STAFF REPORT

SUBJECT: Third Party Analysis of E. Covell Corridor Plan by Mobycon

EAST COVELL CORRIDOR PLAN

Third Party Review - Final Report

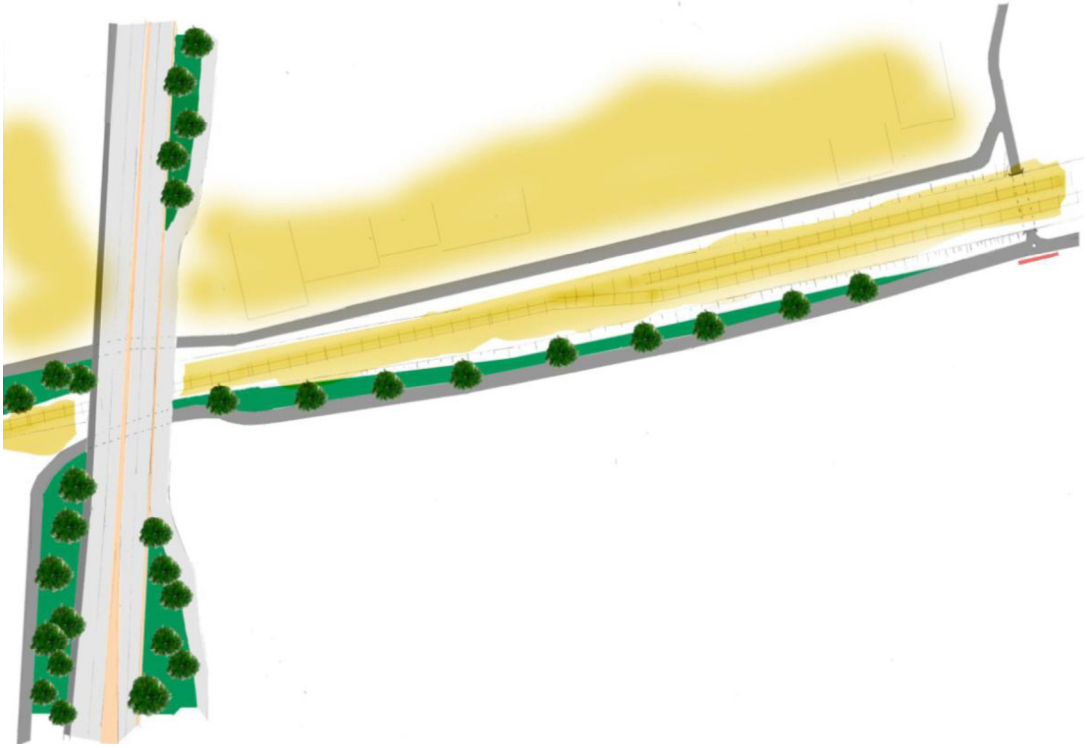
The western entrance/exit of the H Street tunnel currently consists of narrow and sharp turns that lead the cyclists to and from F Street via a graded path. In order to provide the cyclists with more visibility, and therefore prevent unsafe maneuvers, the graded slope between F Street and the tunnel entrance/exit can be replaced by a retaining wall. A retaining wall would create space to accommodate bicycles turning into and out of the tunnel. This has been proposed in the East Covell Corridor Plan of March 2014. To encourage cyclists adapting their speed and trajectory – for example a bicyclist riding southbound on F Street entering the tunnel eastbound – curb extensions at the entrance/exit of the

tunnel should be constructed, as well as a mini roundabout, or alternatively, a “punaise” (see pictures on page 32). Ideally, the grade of the bicycle entrance/exit should not exceed 7% (CROW Design Manual of Bicycle Facilities, 2006). The proposed entrance/exit design does not interfere with the existing F Street on-street car parking, located on the other side of the street.

Additionally, lighting the tunnel at night will enhance the sense of social safety for those who feel vulnerable. Blue LED lights are generally preferred over red LED lights for research has shown that blue light enhances the feeling of safety where red light worsens it. Finally, adding lighting to the tunnel also brings physical safety, as it is easier for pedestrians and bicyclists to see each other and perceive each other’s reactions. Figure 17 shows the sketch design for the tunnel.

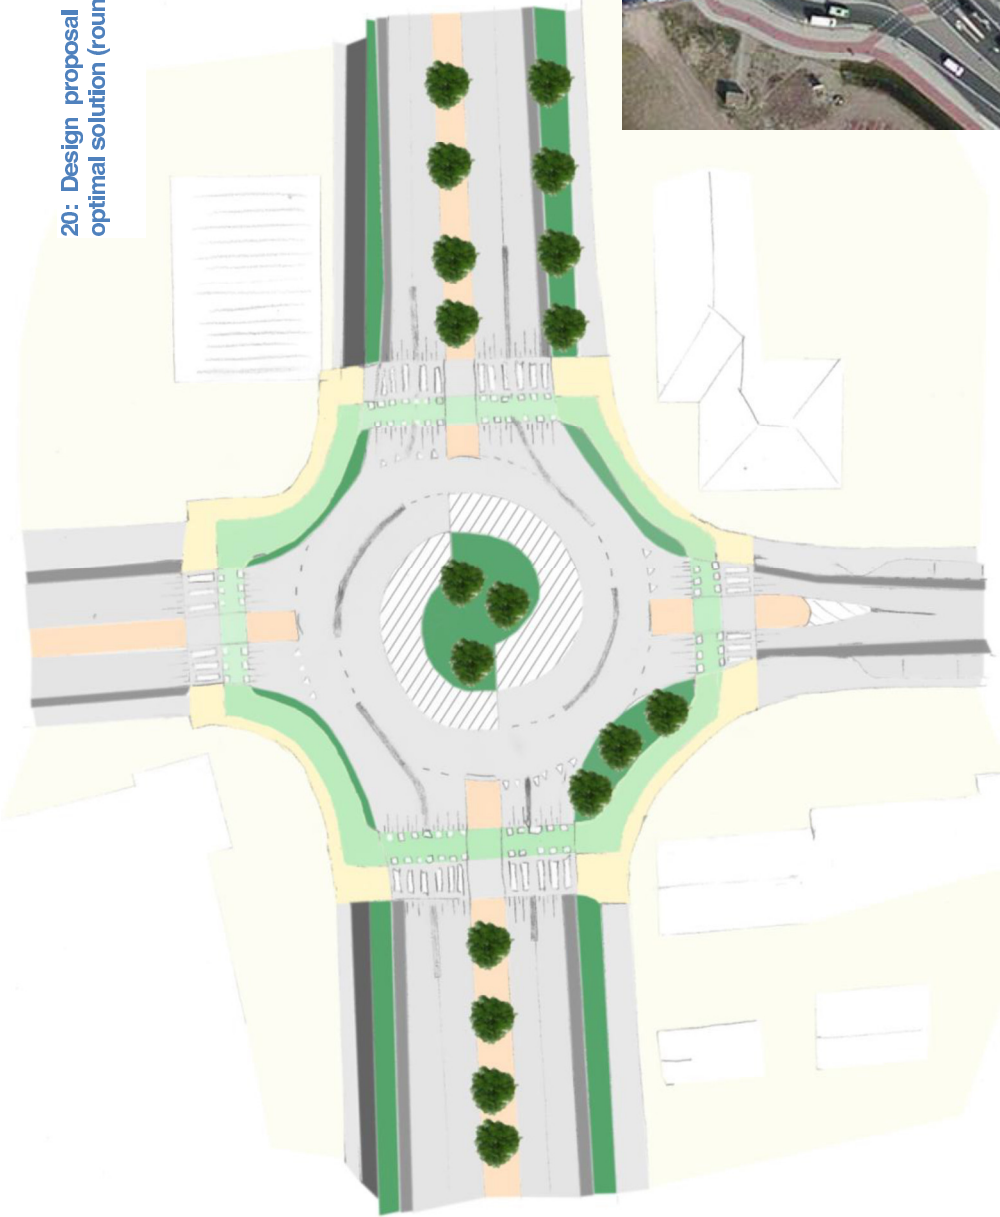
An at-grade crossing is preferred here since an intersection already exists. This at-grade crossing should consider all users: children, commuters and leisurely riders. This means that the design should be safe, comfortable, and able to accommodate large numbers of motorized vehicles and bicyclists, especially during peak hours. The East Covell Corridor Plan of March 2014 suggests removing the channelized right-turn lanes and adding pedestrian crosswalks on the north and east legs of the intersection. These are good measures, but the City can take them a step further for better safety for bicyclists.

Protecting cyclists at the intersection is the minimum solution for traffic safety. The shared path on the south side must cross next to the pedestrian crossing, with a protective shoulder between the pedestrian and cycle crossing and the intersection. This type of intersection, the 'Dutch Junction' provides more safety with any difficult traffic light phasing; the cycle phase is together with the pedestrian phase. A stepping stone is provided in the crossing of E. Covell Boulevard by the median in the middle of the road. Thus, cyclists do not have to merge with car traffic on the difficult and busy intersection.

5.3 East Covell Blvd. and Pole Line Road intersection (Map item 3)

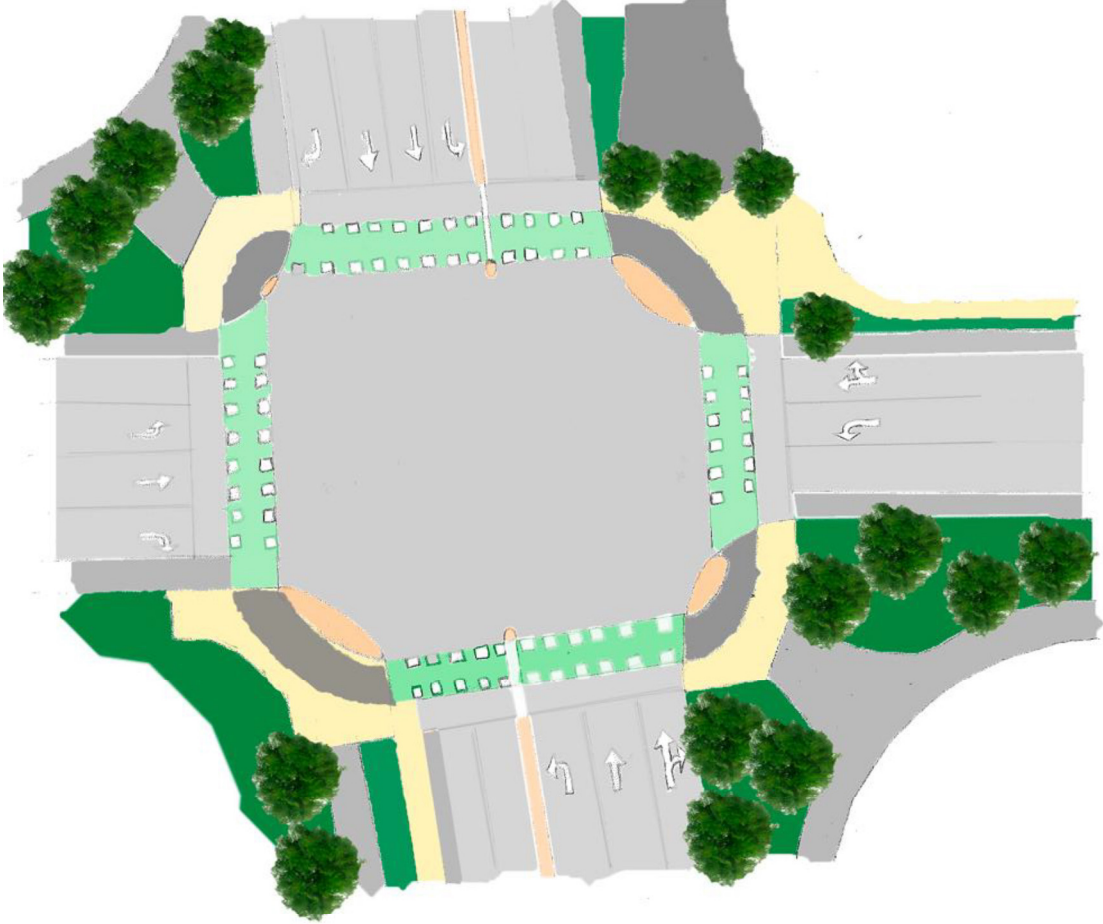
The intersection of Pole Line Road and East Covell Boulevard is one of the busiest in the City of Davis. Through traffic, inbound and outbound traffic, cyclists, and pedestrians mix in a wide-open asphalt intersection. In order to make this intersection safe for all users and thus encourage the use of the bicycle even for the outlying neighborhoods (Cannery, but also Green Meadows, etc.), it is important to emphasize separated cycle facilities, even at this busy junction.

The first step is therefore to eliminate the channelized right turn lanes for cyclists' safety purposes, as suggested in the East Covell Corridor Plan of March 2014. Channelized right turn lanes indeed accommodate fast motorized traffic movement due to their large curb radii at intersections. Eliminating these channelized right

turn lanes will allow small-radius curbs that better protect slow non-motorized transport users from turning vehicles. The right-turn pockets proposed in the ECCP 2014 Plan do not provide enough safety for cyclists traveling through the intersection because the bicyclists can be positioned in the driver's blind spot.

To solve that potentially unsafe situation the Dutch move the cycle crossing slightly further back out of the intersection, together with and next to the pedestrian crossing. The crossings are moved onto the oncoming branches, where the crossing distance is smaller and conflicts are less. Besides that, there is now room for the construction of raised shoulders at the corners of the intersection, which provide cyclists and pedestrians more safety. The shoulders indeed force motorized traffic to take sharp turns when turning right that will lead to meeting bicycle and pedestrian crossings at a 90-degree angle. This is an essential part of the design as a lot of collisions between bicyclists and motorized traffic occur at intersections due to poor visibility (the angle between the two trajectories being very small in those cases). Typically, the distance between the through-movement lane and the parallel bicycle crossing is at least one length of a standard car. Another advantage of diverting the bicycle way out of the intersection core while eliminating the channelized right-turn lanes is that bicyclists can effectively turn right at any time, irrespective of traffic lights and signalization.

Minimal form for the roundabout at J-street – E. Covell Boulevard in morning rush hour with Cannery.

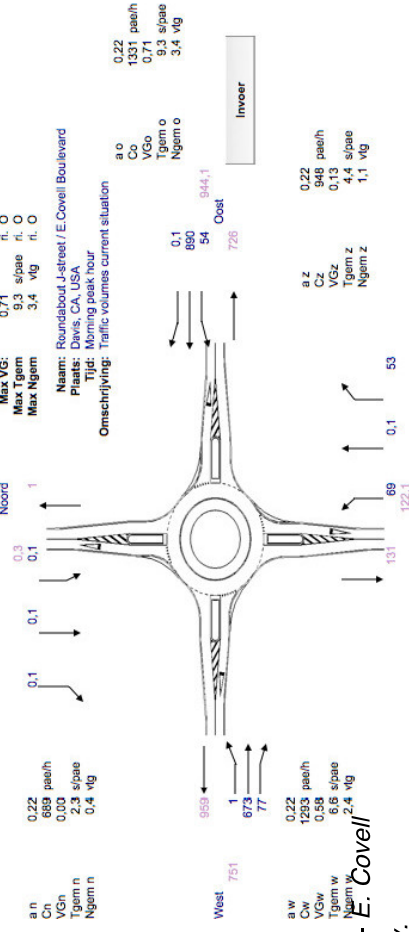
For the morning rush hour both in the current situation (without the Cannery) and in the new situation (with Cannery, with educated guess traffic volumes of 250 leftwards, 60 straight on and 220 east wards)

and 220 cars/hour from the east) shows that a single lane roundabout is lacking capacity. Several types of turbo roundabouts are possible. The chosen shape has the least entry and/or exit lanes, to make crossing them

Minimal form for the roundabout at J-street – E. Covell Boulevard in afternoon rush hour with Cannery.

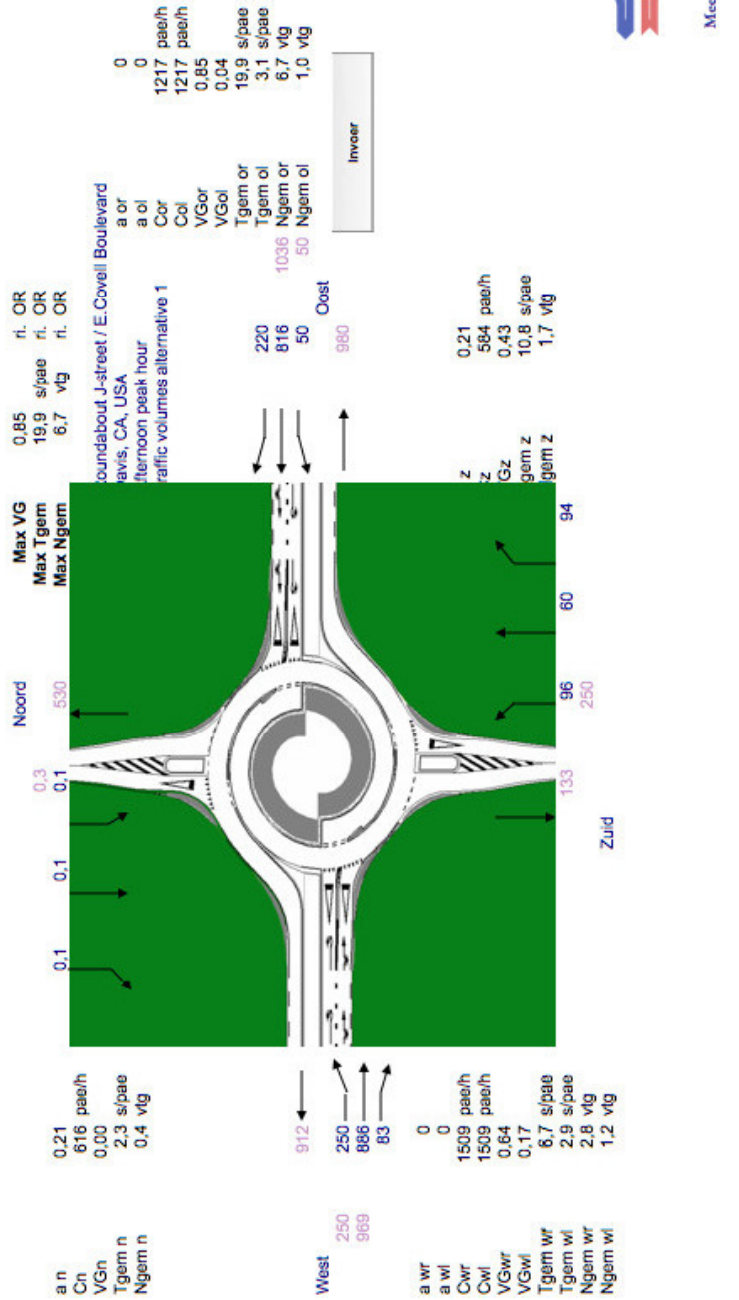
The afternoon rush hour makes up for higher traffic volumes. With the Cannery neighborhood (again modeled with estimated guess traffic volumes of 250 cars/hour from the west, 60 cars/hour from the south for slow traffic as safe and convenient as possible.

This shape of roundabout is visible in the figure. Average waiting times per direction are listed. These are all lower than the average waiting time for the traffic light. The level of service went up, while traffic safety for cars, pedestrians and cyclists can rise as well.
